OYSTER CREEK NUCLEAR GENERATING STATION

PROVISIONAL OPERATING LICENSE DPR-16

(DOCKET NO. 50-219)

Applicant hereby requests the Commission to change Appendix A to the above captioned license as follows:

Figure 3.3.1

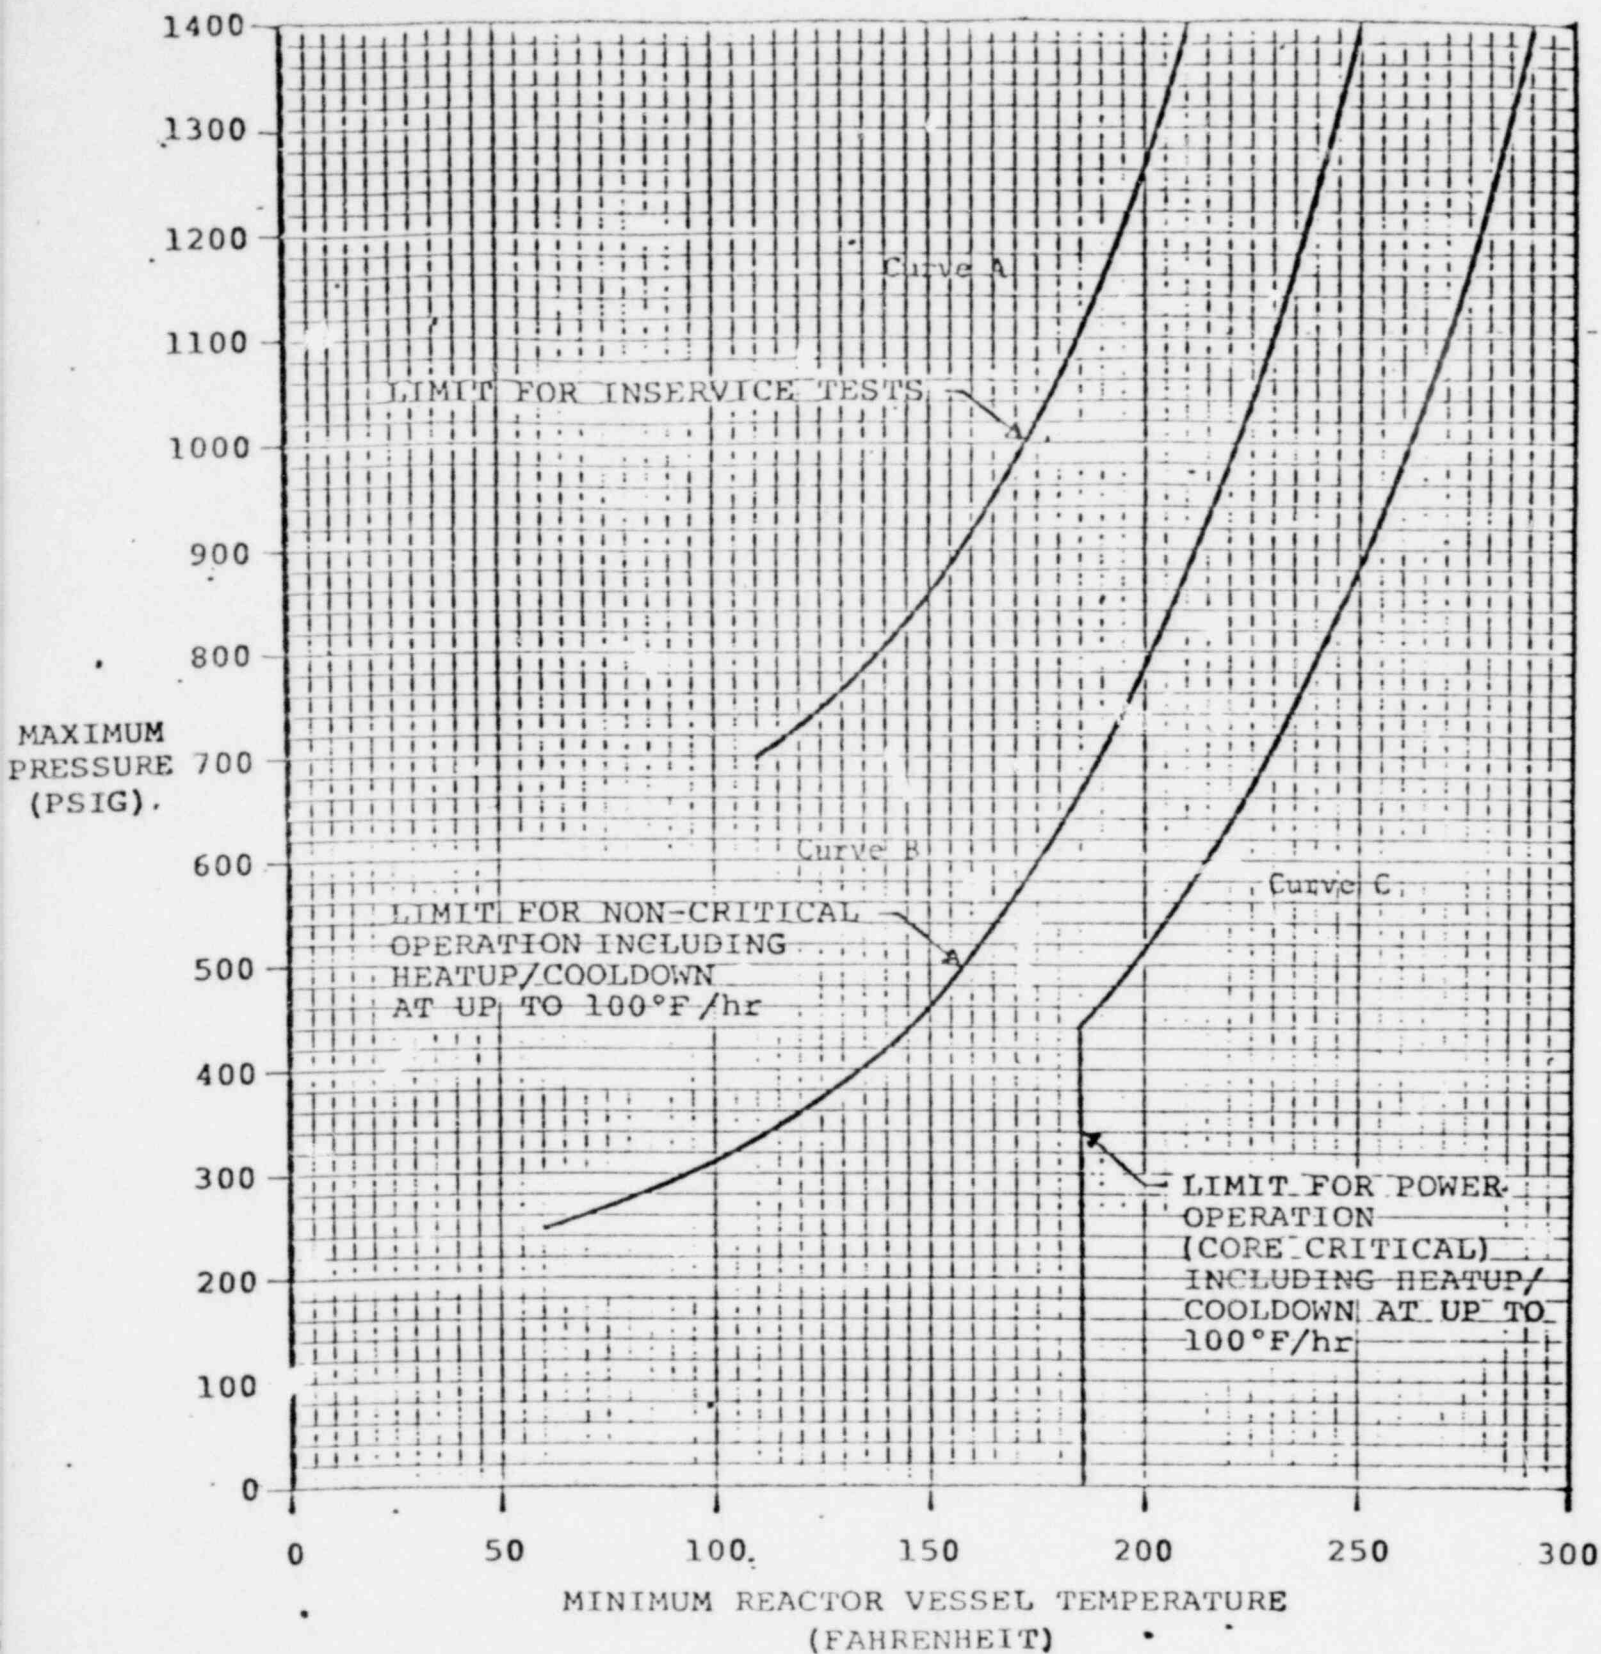
A. Delete old Figure 3.3.1 and replace with new Figures 3.3.1

- (i) Hydrostatic Leakage Tests - the minimum reactor vessel temperature for hydrostatic leakage tests at a given pressure shall be in excess of that indicated by curve A of Figure 3.3.1.
- (ii) Heatup and Cooldown Operations: Reactor non-critical--the minimum reactor vessel temperature for heatup and cooldown operations at a given pressure when the reactor is not critical shall be in excess of that indicated by Curve B of Figure 3.3.1

(iii) Power operations--The minimum reactor vessel temperature for power operations at a given pressure shall be in excess of that indicated by curve C of Figure 3.3.1.

Figure 3.3.1 is derived from an evaluation of the fracture toughness properties performed for Oyster Creek (Reference 12) in an effort to establish new operating limits. The results of neutron flux dosimeter analyses in Reference 12 indicate that the total fast neutron fluence (>1 Mev) expected for Oyster Creek at the end of ten effective fuel power years of operation is 1.22×10^{18} nvt on the inside surface of the reactor vessel core region shell. A conservative fast neutron fluence of 75% of this value is assumed at the 1/4 T (one quarter of wall thickness) location for the preparation of the pressure/temperature curves in Figure 3.3.1.
